PIC16(L)F1824/1828 Family Silicon Errata and Data Sheet Clarification

The PIC16(L)F1824/1828 family devices that you have received conform functionally to the current Device Data Sheet (DS41419A), except for the anomalies described in this document.

FIGURE 1: INSTRUCTION CYCLE DELAY CALCULATION EXAMPLE

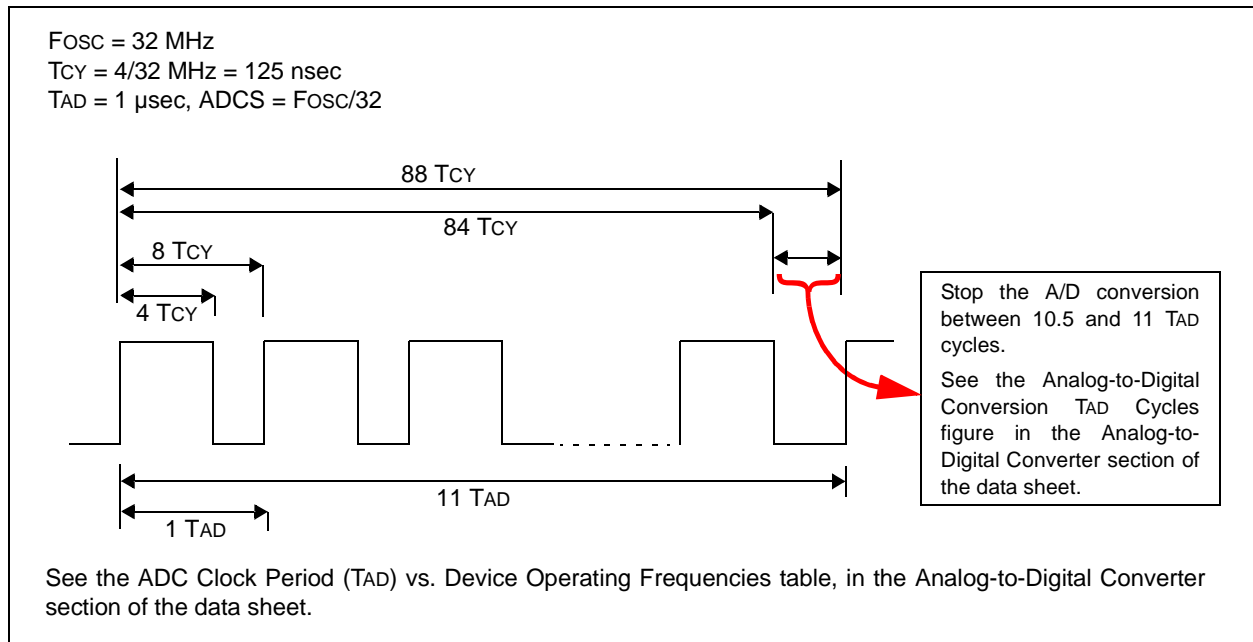
An ADC conversion may not complete under these conditions:

1. When FOSC is greater than 8 MHz and it is the clock source used for the ADC converter.
2. The ADC is operating from its dedicated internal FRC oscillator and the device is not in Sleep mode (any FOSC frequency).

When this occurs, the ADC Interrupt Flag (ADIF) does not get set, the GO/DONE bit does not get cleared, and the conversion result does not get loaded into the ADRESH and ADRESL result registers.

Method 3: This method is provided if the application cannot use Sleep mode and requires continuous operation at frequencies above 8 MHz. This method requires early termination of an ADC conversion. Provide a fixed time delay in software to stop the A-to-D conversion manually, after all 10 bits are converted, but before the conversion would complete automatically. The conversion is stopped by clearing the GO/DONE bit in software. The GO/DONE bit must be cleared during the last 1/2 TAD cycle, before the conversion would have completed automatically. Refer to [Figure 1](#) for details.

In Figure 1, 88 instruction cycles (Tcy) will be required to complete the full conversion. Each TAD cycle consists of 8 Tcy periods. A fixed delay is provided to stop the A/D conversion after 86 instruction cycles and terminate the conversion at the correct time as shown in the figure above.

Note: The exact delay time will depend on the TAD divisor (ADCS) selection. The Tcy counts shown in the timing diagram above apply to this example only. Refer to Table 3 for the required delay counts for other configurations.
